City of Pembroke Pines
Planning & Economic Development Department
601 City Center Way 3rd Floor
Pembroke Pines FL, 33025

Agenda Date:	November 14, 2024	Application ID:	MSC 2024-0019
Project:	Turbo Shot Coffee Shop	Project Number:	N/A
Project Planner:	Julia Aldridge, Planner / Zoning Technician		
Owner:	Sonny's Enterprises, LLC	Agent:	Angel Pinero
Location:	8579 Pines Boulevard	Commission District:	2
Existing Zoning:	Community Business (B-2)	Existing Land Use:	Commercial
Reference Applications:	SP 92-34, SN 93-26		
Applicant Request:	Architectural and signage modifications to an existing building.		
Staff Recommendation:	Approval		
Final:	<input checked="" type="checkbox"/> Planning & Zoning Board	<input type="checkbox"/> City Commission	
Reviewed for the Agenda:	Director: 	Assistant Director:

Angel Pinero, agent, is requesting approval for exterior architectural and signage modifications to Turbo Shot Coffee Shop (formerly Checkers Restaurant) located at 8759 Pines Boulevard. The existing building was approved through SP 92-34. There will be no changes to the existing building footprint, parking and traffic circulation from the previously approved site plan.

FIRE HYDRANT DETAIL

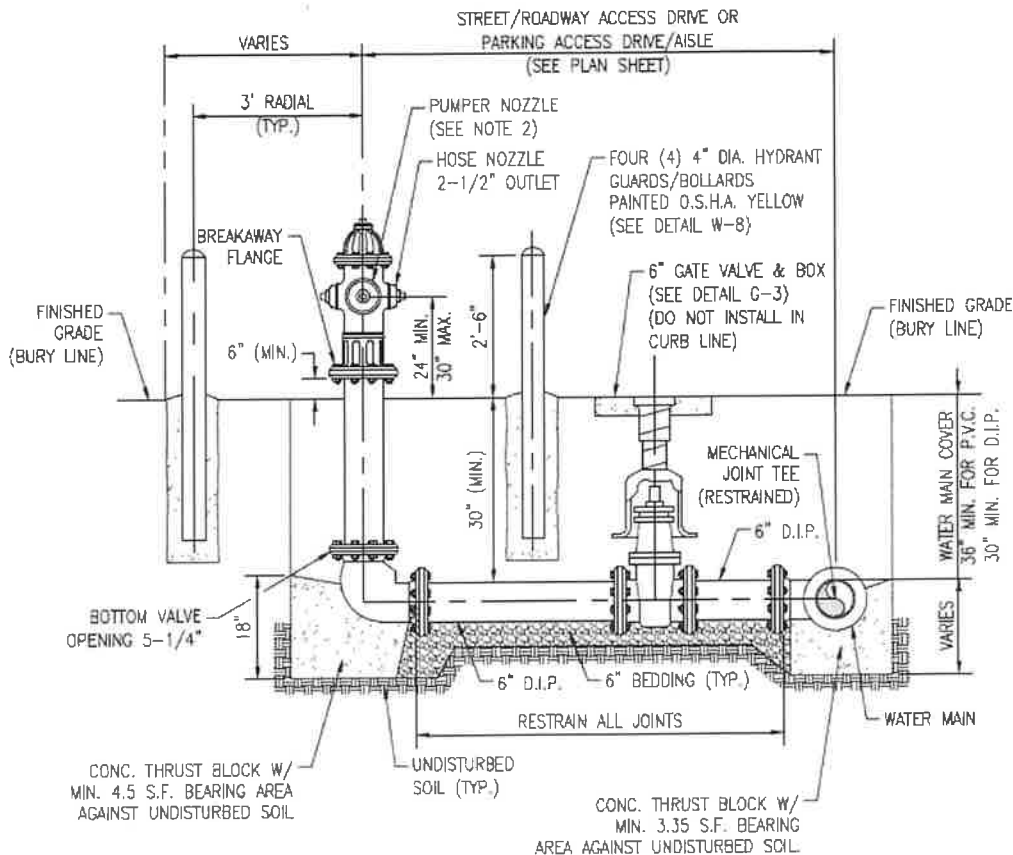
NOTE: Fire Hydrant Detail to be provided on submittal.

i. No tree, bush, hedge, or shrub, shall be planted within 15 feet diameter of a hydrant and located such that the hydrant shall be fully visible from the street. **COPP CO 93.25 (F)**

Sign Post with 3" x 7 ga. Square Anchor

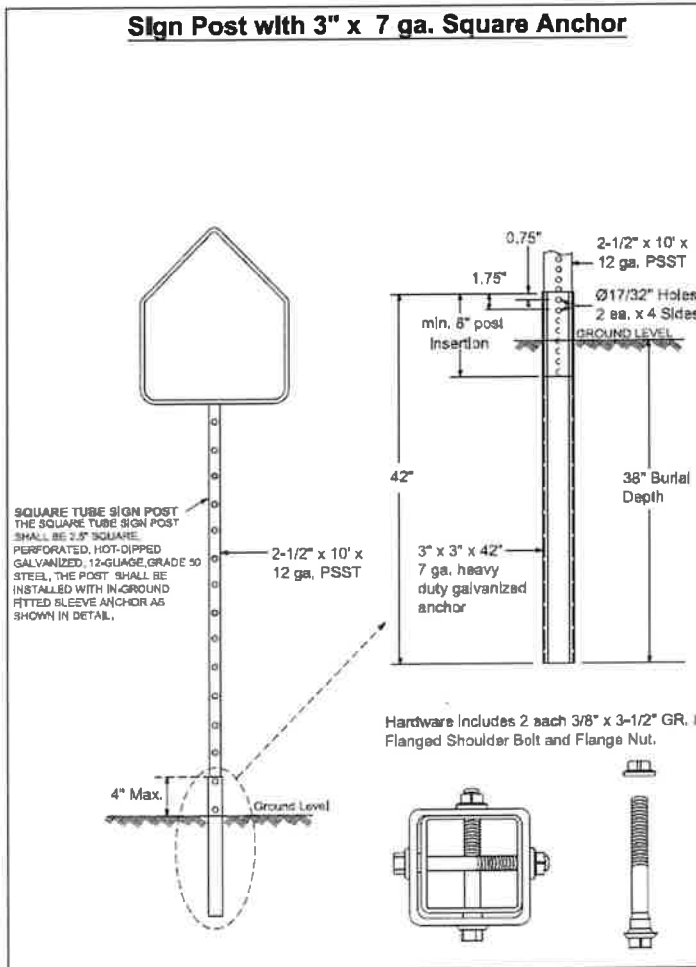
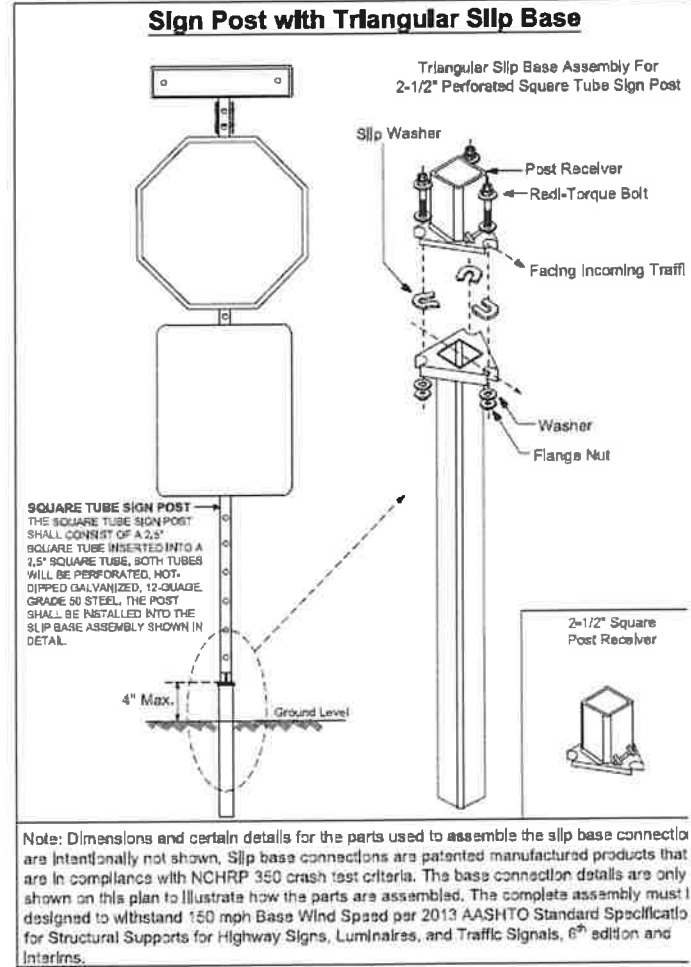
21. Place note on plan: All Support/Sign Posts Shall Conform To Current Broward County Traffic Engineering Division (BCTED) Standards For Square Tube Sign Posts With Either A Square Anchor Or Triangular Slip Base per BCTED 'Ground Sign Assembly Details'.

NOTE: Detail Provided Below

PAVEMENT MARKINGS AND SIGNAGE PLAN

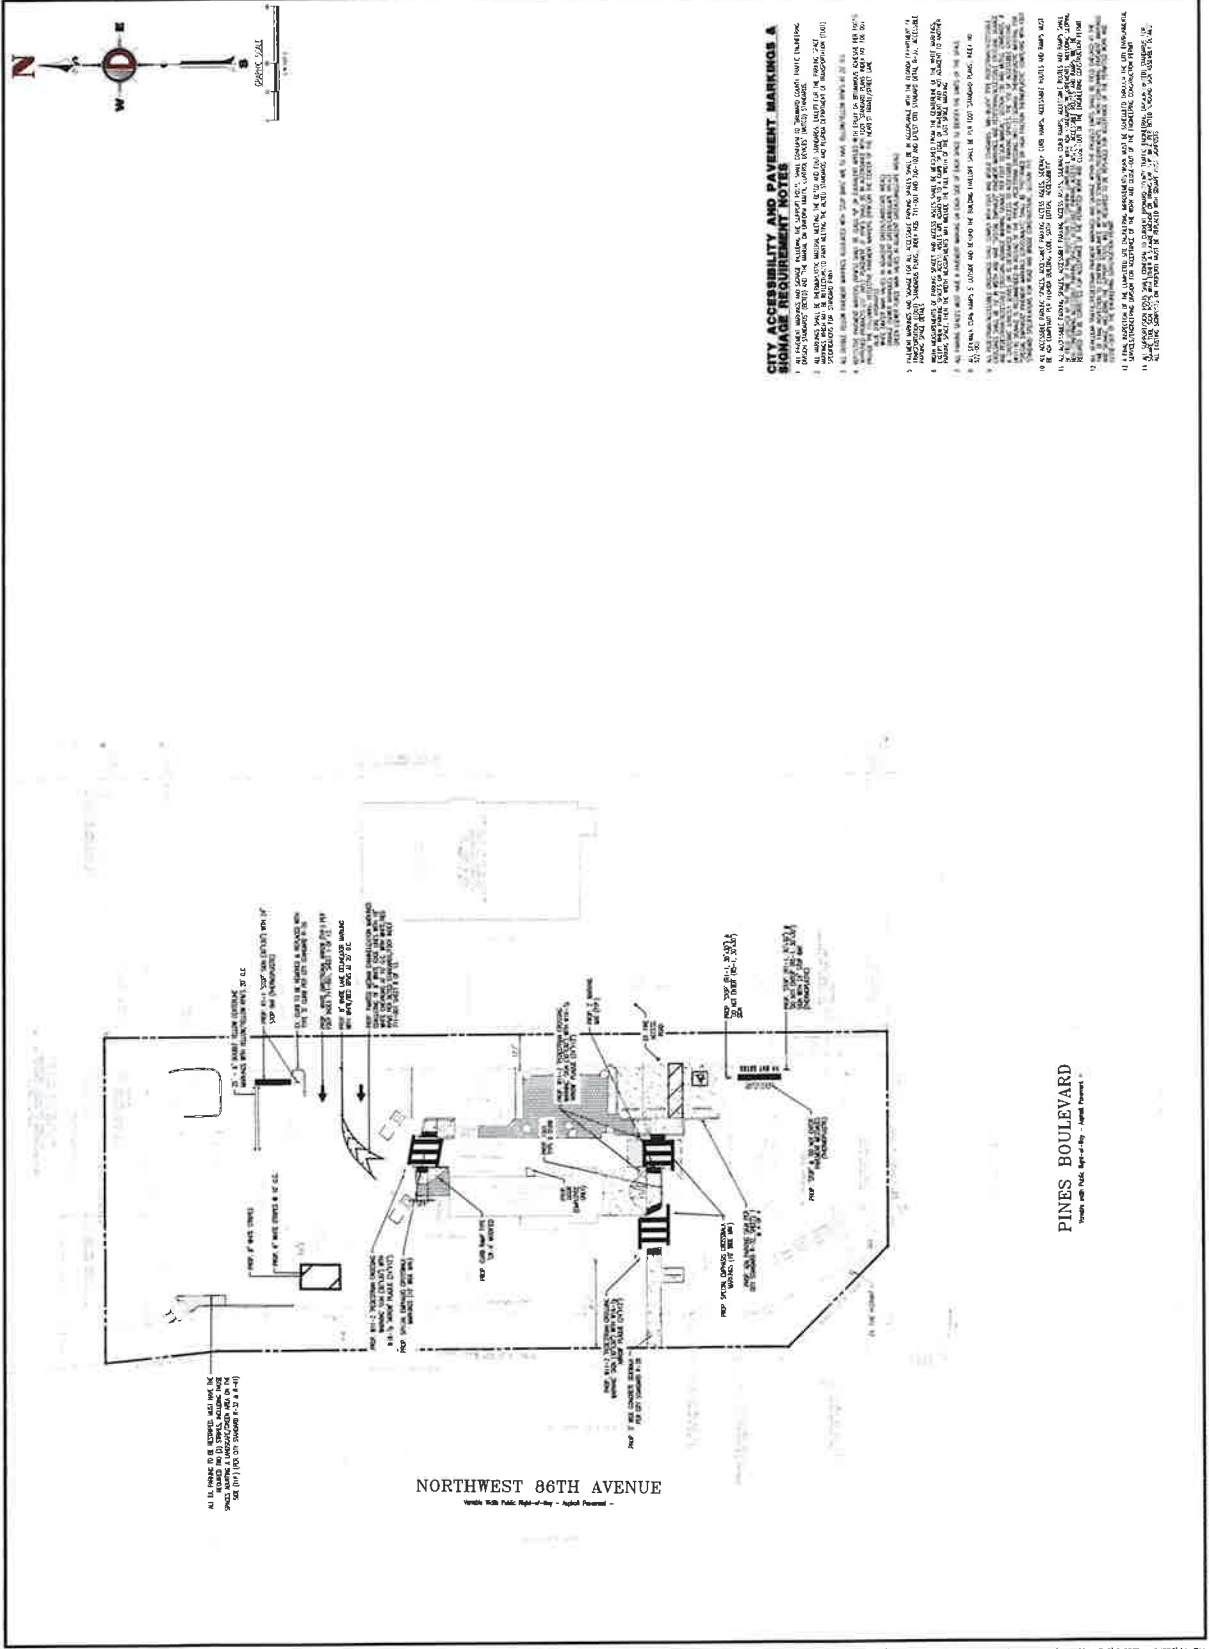
17. All signage on property needs to be updated per Broward County Traffic Engineering division standards. Add call outs to all signs being updated and add details to set.
18. All pavement Marking on property needs to be updated to meet Broward County Traffic Engineering division & City of Pembroke Pines standards. Provide separate pavement marking plan sheet and add details to set.
19. All parking spaces must have the required two (2) stripes, including those spaces abutting a landscape/green area on the side (TYP.) (per city standard R-32 & R-41).
20. Confirm with zoning if the existing dumpster enclosure needs to be replaced and/or refurbished. The existing dumpster enclosure is in poor condition.
21. The city recommends checking the condition of the existing concrete. If the concrete is found to be in poor condition, it should be repaired and resurfaced in the drive-thru area.

SOUTH (FRONT) ELEVATION

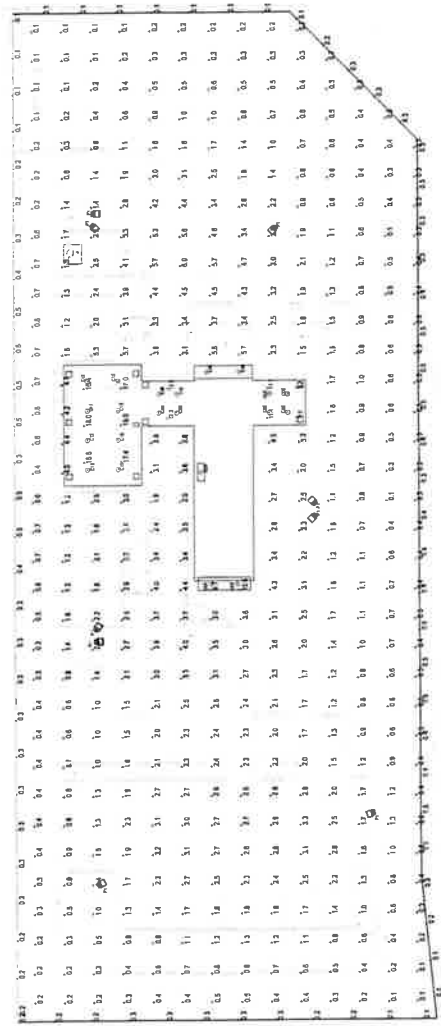
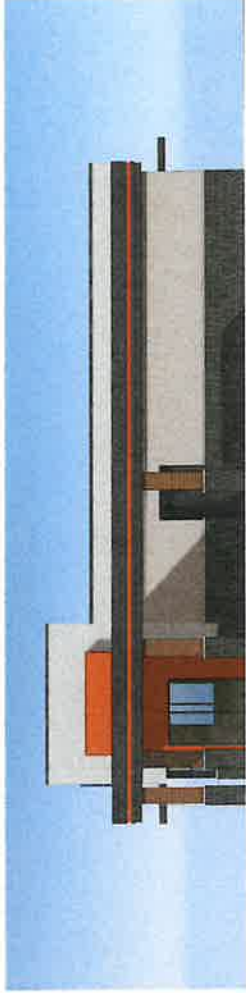
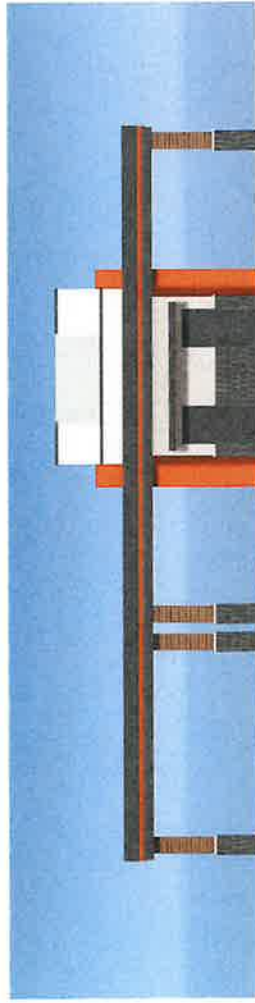
4. Provide detail(s) showing all roof mounted equipment is screened from view for a 6' person at the property lines.
5. Provide all elevations in black and white.

8. Provide details of canopy clearance bars.
9. Please add a note to the plans that the garbage enclosure will be painted to match the building façade.
10. Provide black and white elevations. Provide all color names, color number, finishes, materials, etc. on both color and black and white elevations.
